UNITED STATES PATENT AND TRADEMARK OFFICE

Office Action Summary	Application No. 10/521,387	Applicant(s) LUTTMANN ET AL.	
	Examiner Michael L. Hobbs	Art Unit 4151

DETAILED ACTION

Figure 1: Automated production of recombinant proteins (Cornelissen et al.)

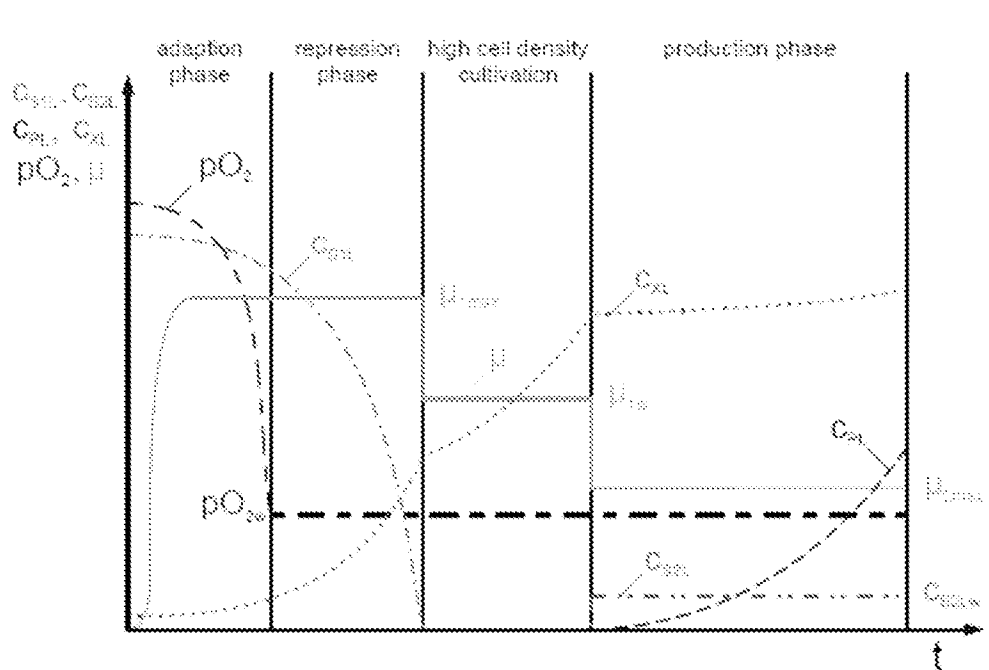
valuable products as in claim 5, Cornelissen teaches that the cells adapt to the medium and that the cells are propagated at a constant growth rate, μ , for the batch phase (page 3 sections 3 and 4, Fig. 2). At the time of the invention, it would have been obvious to one of ordinary skill in the art to employ the steps of producing recombinant proteins of Cornelissen within the teachings of Kopf in order to separate and control the growth of the desired product. The suggestion for doing so at the time would have been to implement steps that are reproducible and enable stable production conditions (page 6 section 8).

23. For claim 7, Cornelissen teaches the step of using a flow diffusion analysis (FDA) to regulate a second feed receptacle (page 3 section 4, Fig. 3). At the time of the invention, it would have been obvious to one of ordinary skill in the art to employ the step of using a flow diffusion analysis device within the teachings of Kopf in order to control the flow of nutrient or medium to the bioreactor. The suggestion for doing so at the time would have been to prevent possible fouling of the filter (page 3 section 4).

24. Regarding claim 11, Cornelissen teaches the step where the yeast used to produce the **recombinant DNA** is *Pichia pastoris* (Abstract) (claim 11) and for claim 12, Cornelissen teaches the step where the inducing substance is methanol (page 3 section 4, Fig. 1 & Fig. 3). Therefore, at the time of the invention, it would have been obvious to one of ordinary skill in the art to employ the recombinant DNA production of Cornelissen within the teachings of Kopf in order to produce and control the amount of product produced. The suggestion at the time would have been to use *P. pastoris* to produce

25. Regarding claims 13 and 14, Cornelissen teaches maintaining the methanol level at a constant level and that glycerol is fed to the bioreactor (page 3 sections 3 & 4, Fig. 3). At the time of the invention, it would have been obvious to one of ordinary skill in the art to employ the flow and production controls of Cornelissen within the teachings of Kopf to optimize the production of recombinant DNA. The suggestion for doing so would have been to precisely control the amount of product produced and the particular production stage when said product will be harvested.
